# Access Compliance Report

## Public Rights-of-Way

Intersection ID: 52127	Main Street: VALLEYDALE_RD	Cross Street: FRED_D_ALEXANDER_BV	Location: W
ADA ID: 84205FAA6785	Ramp Type: Combination1	Initial Pass/Fail: Fail	Overall Compliance: No
Severity Score: 13.75			
Codes/Mitigation Info/Possible Solution		Field Measurements/Component Compliance

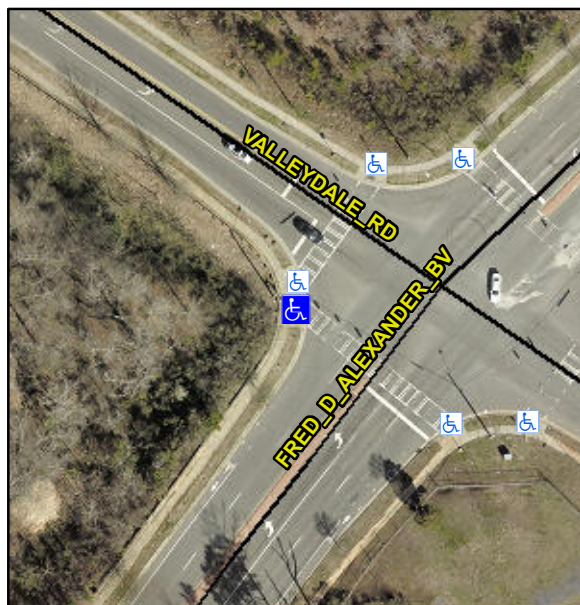
**RP & RT RP < 5%**

**Not Found, R304.5.3, R304.3.2**

**Remove & Replace Entire Ramp.**
